RE: L.G. Everist, Inc.  
Fort Lupton Sand and Gravel, Permit # M-1999-120  
Adequacy Response #4

On behalf of my client L.G. Everist, Inc., I will respond to your August 25, 2025, adequacy review letter, as needed, in the order and number format presented in those documents. We have copied each inquiry into this document for ease of review. I have also revised the Reclamation Cost Estimate (Exhibit L) to add the groundwater drains to Table L11n.

<b>TO:</b>	Lynn Mayer Shults	<b>DATE:</b>	August 12, 2025
<b>COMPANY:</b>	L.G. Everist, Mountain Division	<b>SUBJECT:</b>	Heins Property Groundwater Model Revision 2
<b>ADDRESS:</b>	7321 E. 88th Ave., Suite 200, Henderson, CO 80640	<b>PROJECT NAME/NO.:</b>	L.G. Everist Heins Property 20C26026.06
<b>FROM:</b>	Sampson Ash, PG Victor deWolfe, PE, PG	<b>CC:</b>	Susan Rainey, PE

7/16/2025	PROJECT NO. 20C26026.06	FIGURE #7
-----------	-------------------------	-----------

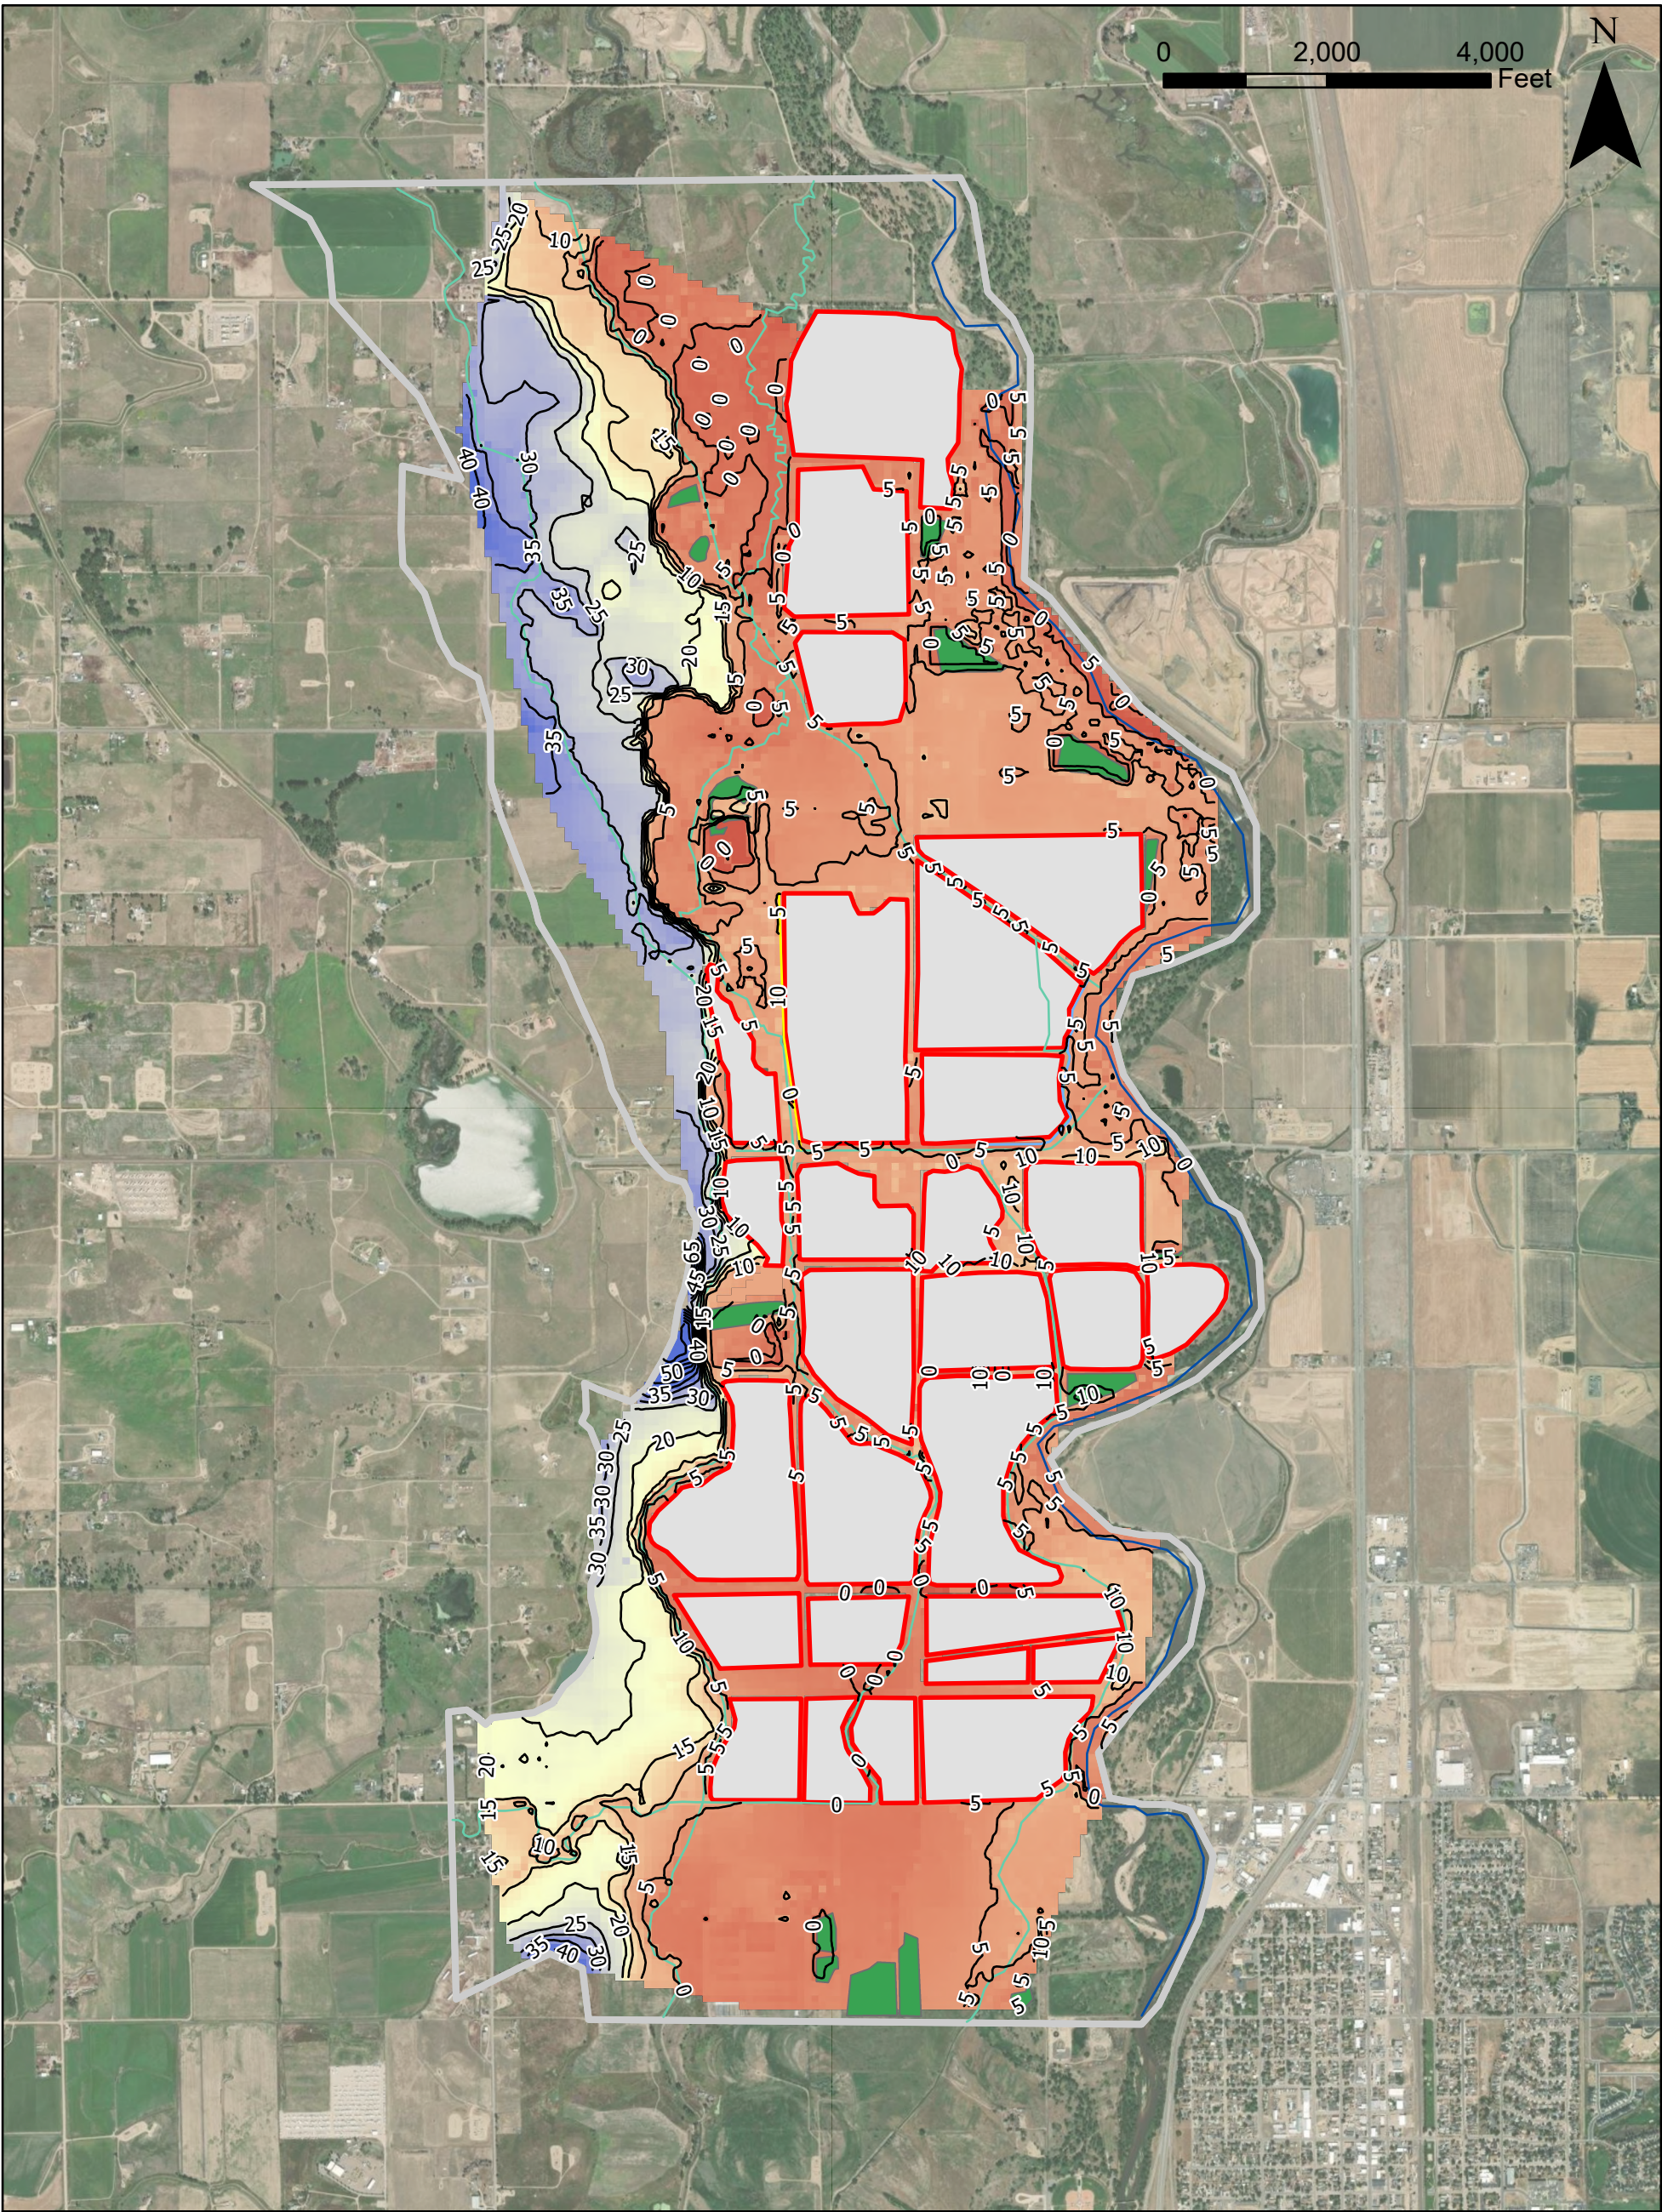
1. Please commit to installing two drains within the permit area.
  - A north-south drain along the western edge of the Heins West slurry wall.
  - An east-west drain along the southern edges of the Southern Complex (Funakoshi, Parker 1-4, and Parker-Adams phases).

The groundwater elevations from the predictive simulation are shown in **Figure 6**. The difference between the pre- and post-slurry wall groundwater surfaces are the predicted mounding levels shown on **Figure 7**. For each of the predictive simulations, positive residuals are reported as values of groundwater mounding (warm colors) and negative values represent groundwater shadowing (cool colors). For this predictive simulation the magnitude of the maximum groundwater mounding is approximately 2.5 feet west of the Heins West and Zadel Pit.

L.G. Everist, Inc. commits to installing 2 groundwater drains as recommended by Schnable Engineering in the revised Heins Groundwater Model memo (dated 08/12/25). A north-south groundwater drain is proposed to be installed along the west side of the Northwest Phase; and an east-west groundwater drain is proposed to be placed on the southern side of the Parker #4 Phase in the approximate locations shown on Exhibit C-1 -Mining Plan and Exhibit F - Reclamation Plan Maps.
